Critique of Cuadrilla's plans and proposals for drilling near Balcombe, West Sussex

David Smythe

Emeritus Professor of Geophysics, University of Glasgow

This slideshow discusses Cuadrilla's published proposals for re-drilling the Balcombe-1 well. Since it is somewhat technical in places, here is a summary:

Cuadrilla: poor interpretation of major faults

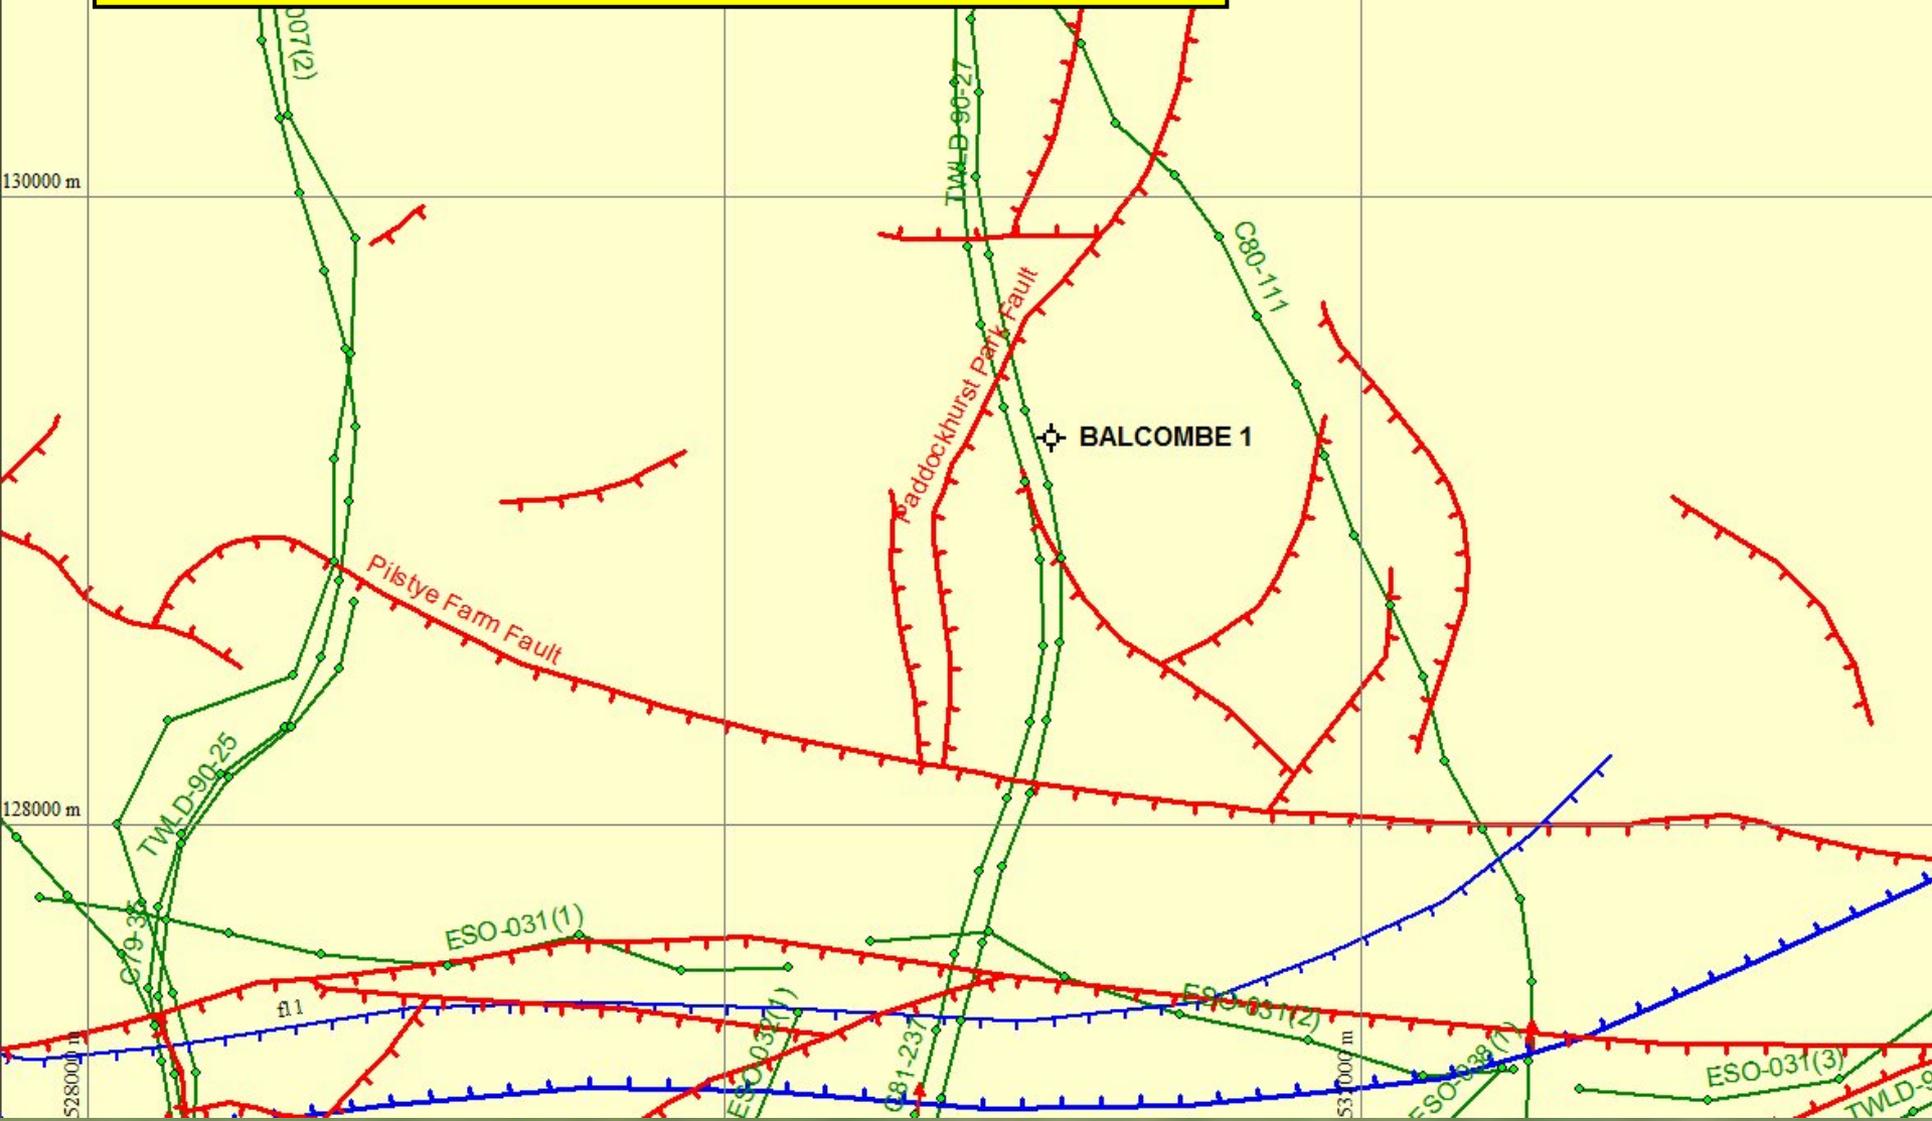
The Cuadrilla interpretation (blue lines) is satisfactory only north of 126000N and from 526000E to 534000E. Everywhere else their fault correlations lead to trends that are 40° or more away from what should be expected from the surface geology. The black lines are a better interpretation.

Cuadrilla: minor faults near the drillsite ignored

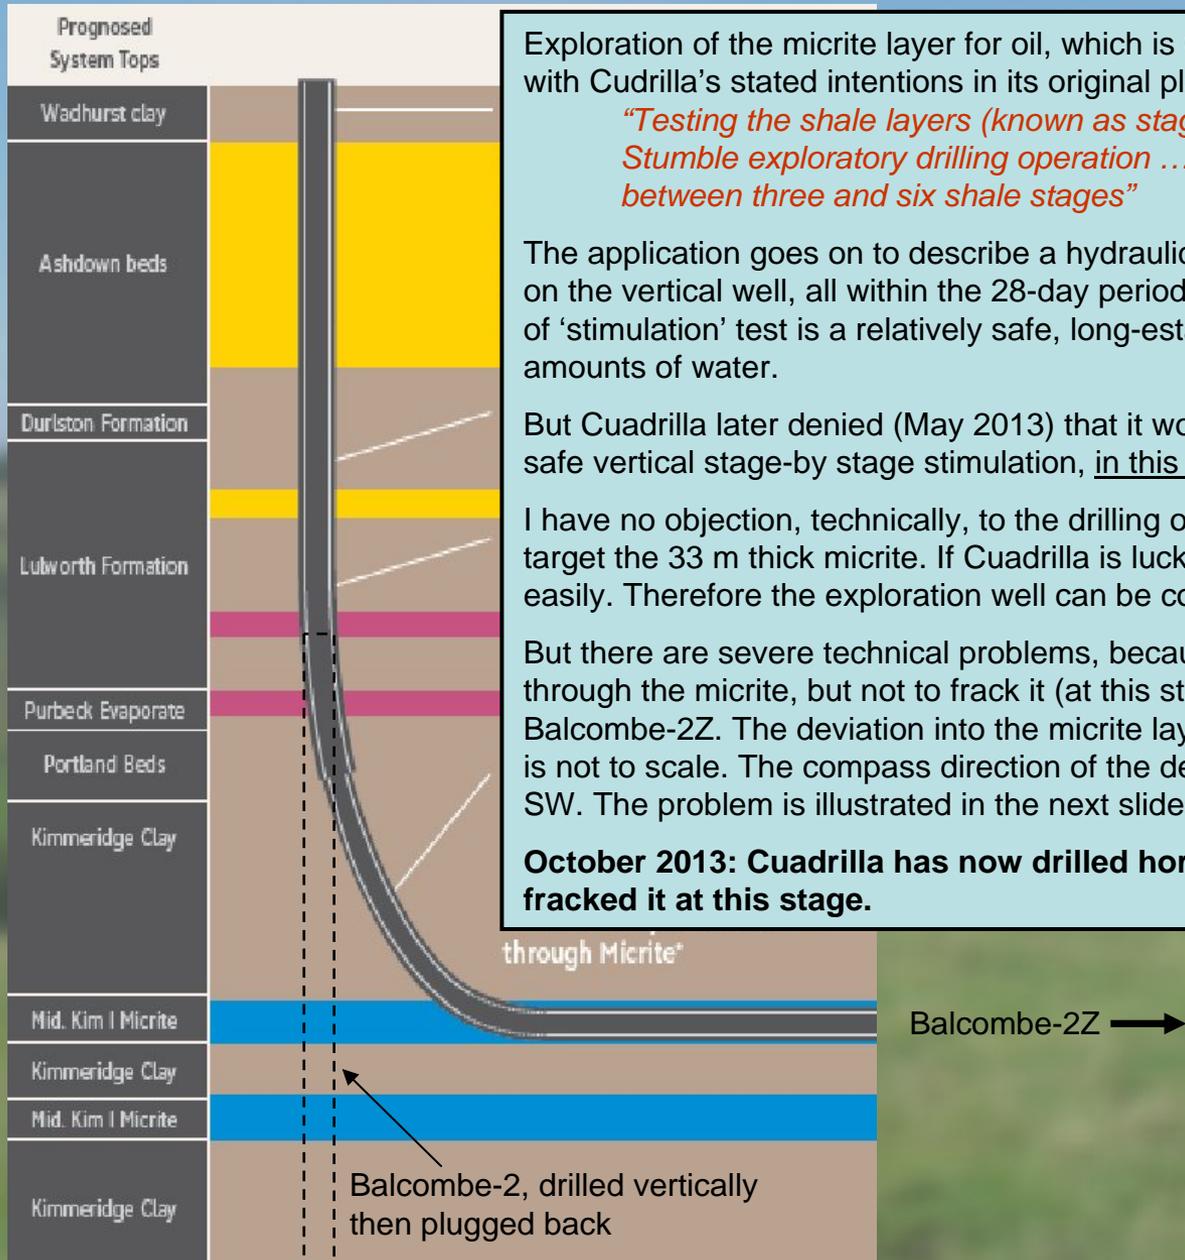
Detailed map around the Balcombe-1 drillsite. BGS faults in red, seismic lines in green, Cuadrilla-interpreted faults at depth shown in blue. The plans for exploration at the well seem to have ignored the many faults around it. The north-south Paddockhurst Park Fault passes 200 m west of the well, and has a throw (displacement of one side vertically relative to the other) of 30-40 m. This fault may intersect the well. The National Grid is shown at a 2 km interval.

Cuadrilla: substantial changes of target rock and drilling intentions

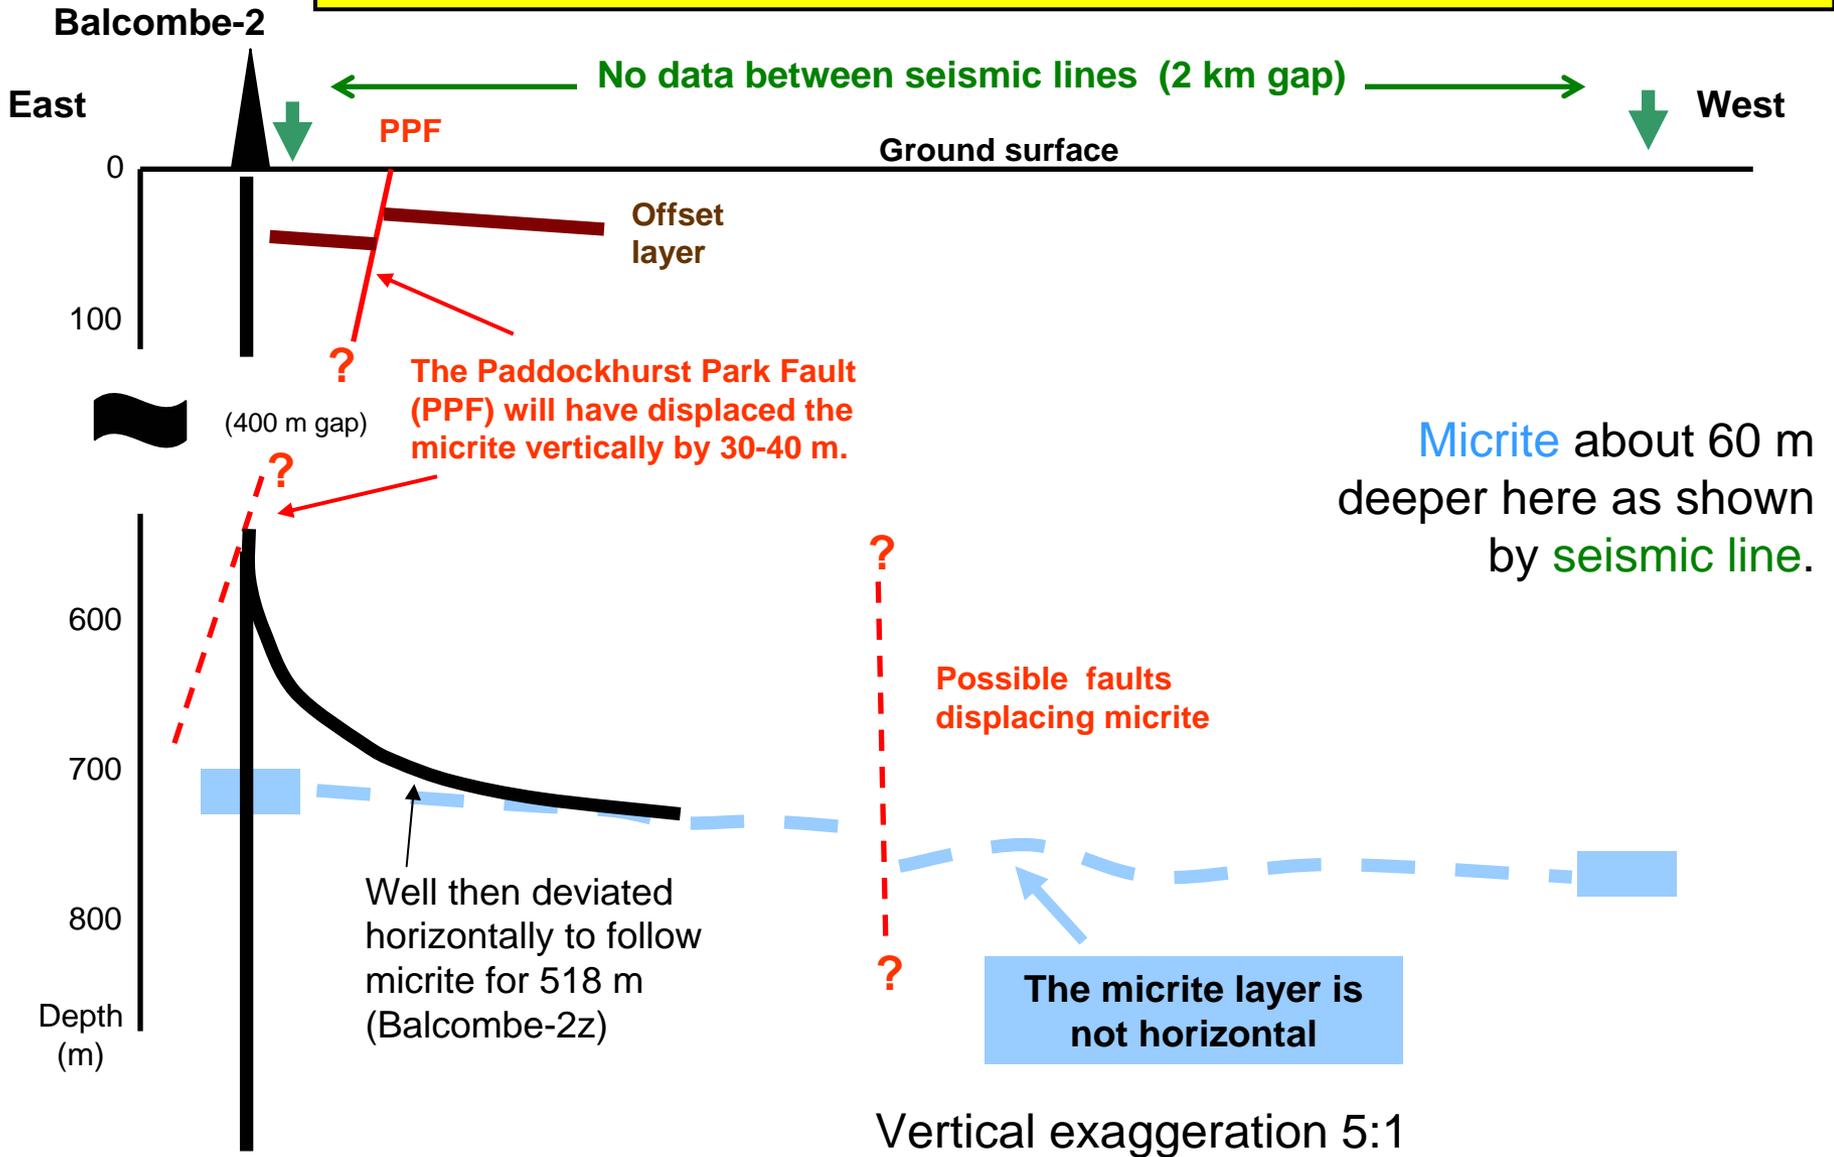
I have no objection, technically, to the drilling of the vertical well (called Balcombe-2) to target the 33 m thick micrite. If Cuadrilla is lucky, the micrite may be full of oil and flow easily. Therefore the exploration well can be converted into an oil production well.

But there are severe technical problems, because Cuadrilla now wishes to drill horizontally through the micrite, but not to frack it (at this stage). This sidetracked well will be named Balcombe-2Z. The deviation into the micrite layer is shown in the diagram on the left, which is not to scale. The compass direction of the deviation is expected to be between NW and SW. The problem is illustrated in the next slide.
